NHTSA 19V190 Recall Remedy Update:

Figure 1: Vehicle Weighing Station

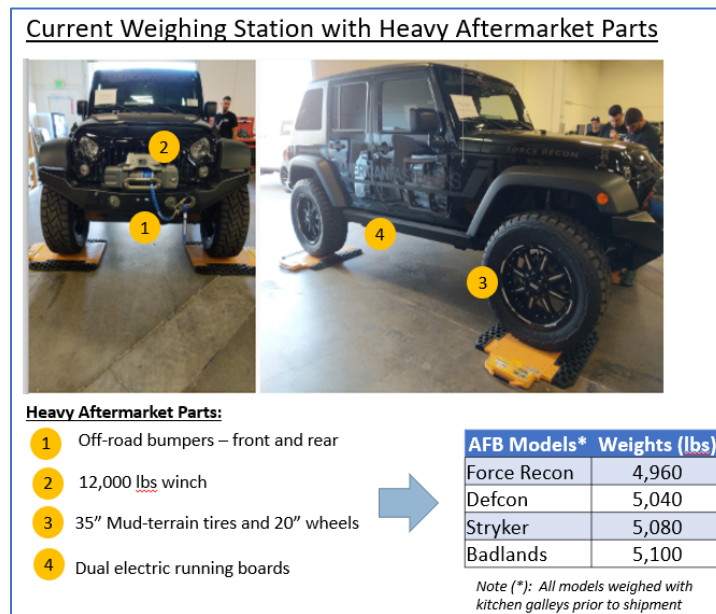
Before transferring title to these Vehicles, the Vehicles will be re-weighed to ensure that the GVWR is acceptable. In addition, to the extent necessary, the Vehicle tire placard will be updated. As shown in Figure 1 below, the Vehicles will be weighed on the following weigh station.
